Notice regarding the change of the A8L series specifications

- Rocker Switch A8L series
- < Refer to the " [Details of applicable model] " . >

Examples of products

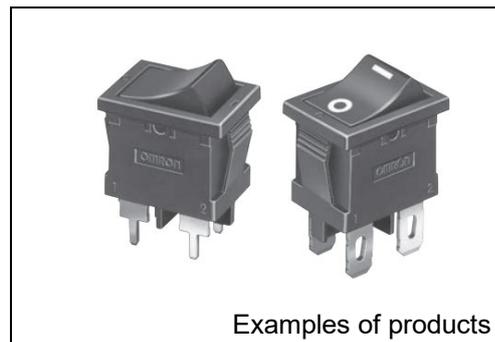
※The specification range is expanded and changed according to customer requirements (operating temperature, operating humidity, impact resistance)..

Before the change	After the change
<p>Change specification items Specified temperature range : - 20°C ~ - 55°C Specified humid range : 45%RH ~ 85%RH Shock value : 500m/s²</p>	<p>We will expand the specifications according to customer requests.</p> <p>Change specification items Specified temperature range : -20°C ~ -85°C Specified humid range : below 85%RH Shock value : 1000m/s²</p>
